### APPEAL SUMMARY

**Appeal ID:** 20543

**Project Address:** 7118 SW 62nd PI

### **Second kitchen in single family residence for family use: Granted as proposed.**

DEAL BASEMENT - EXISTING BASEMENT PLAN  
 SCALE: 1/8" = 1'-0"

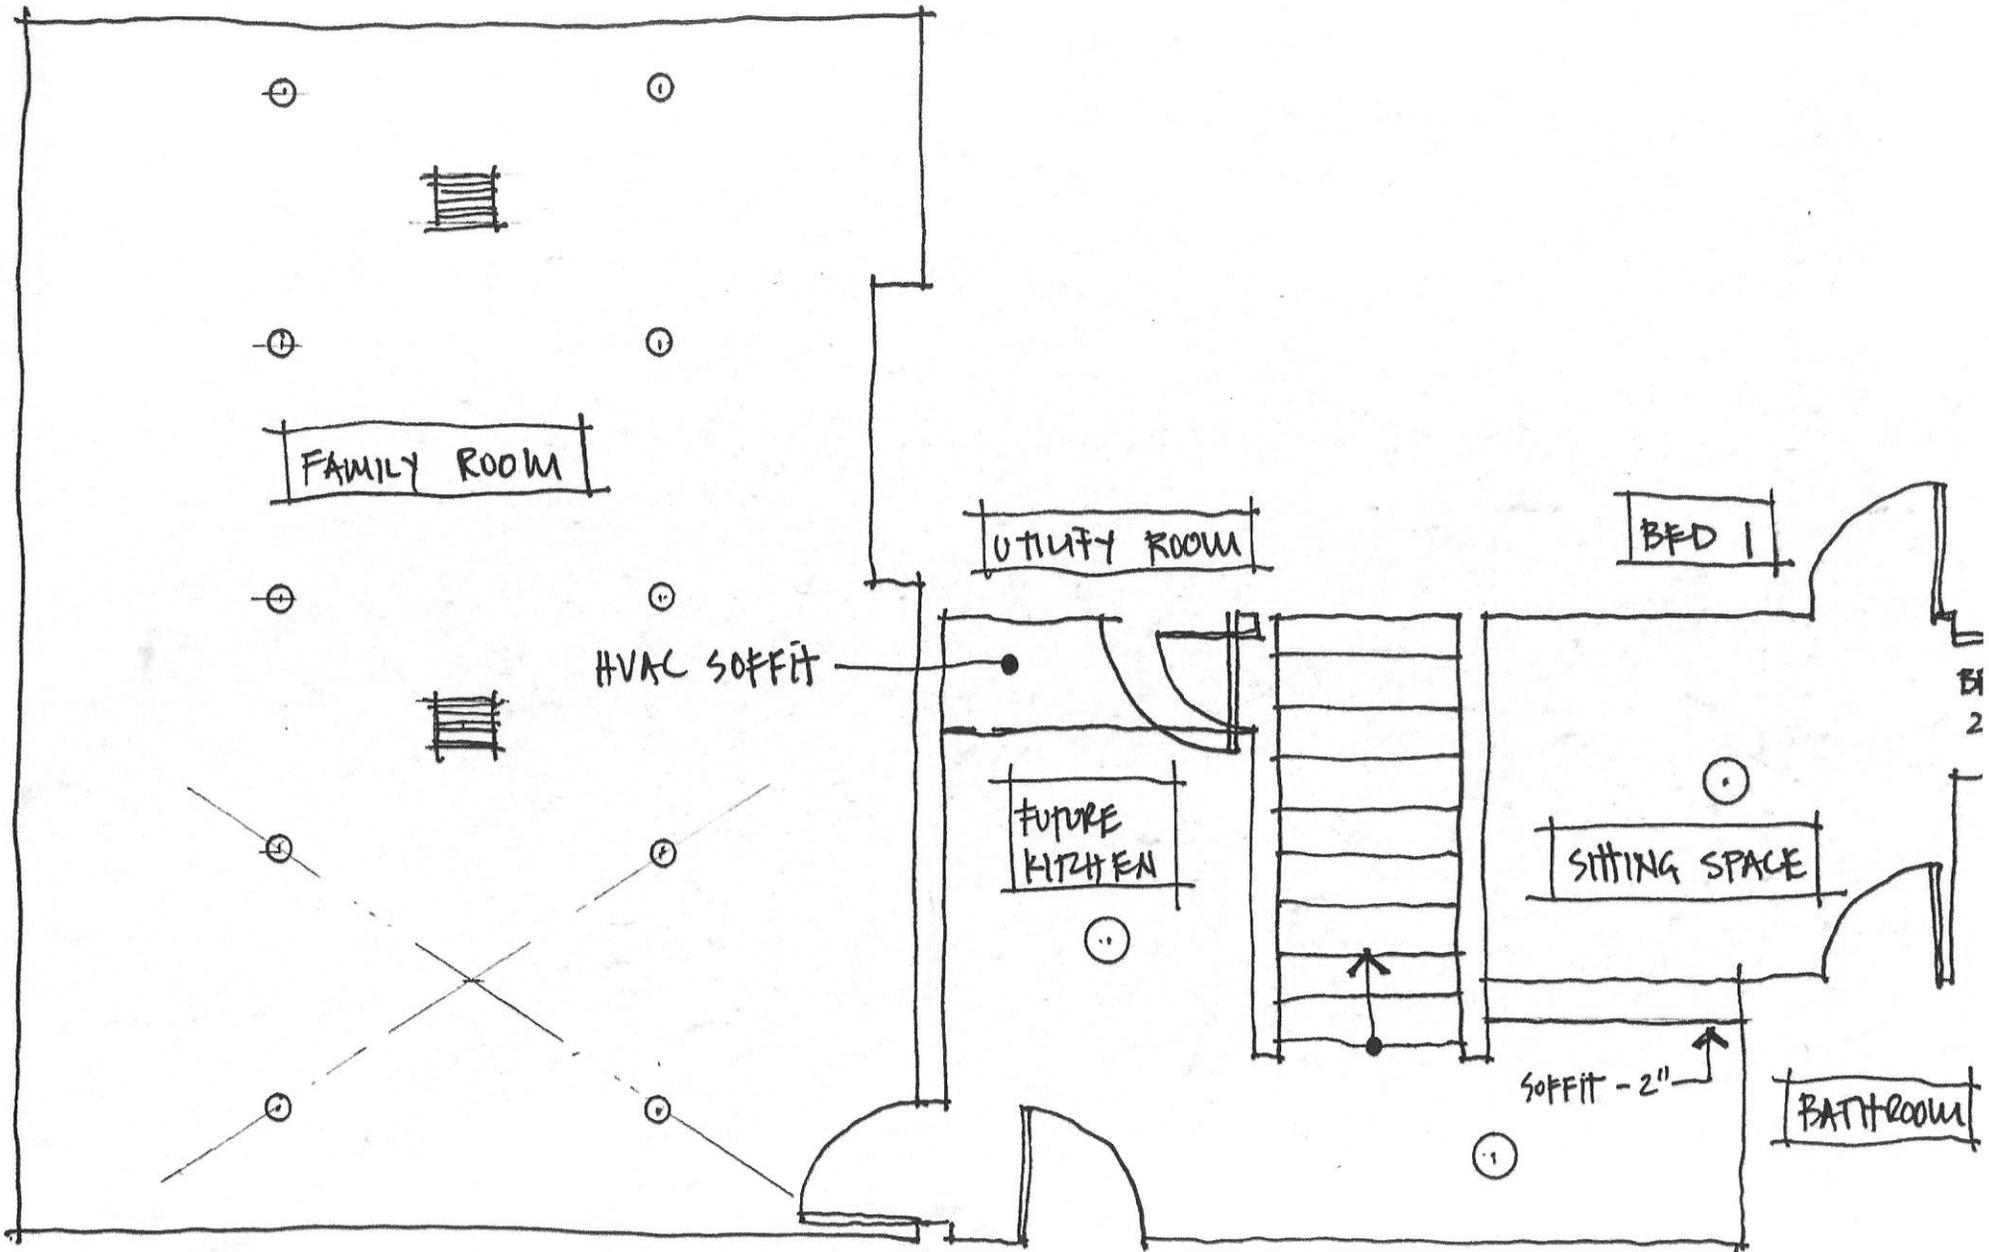
BDS LS DBARTLEY 5/16/19 - 1) Full floor plan of the basement level required. Please provide a plan that shows the full floor where the work is taking place.
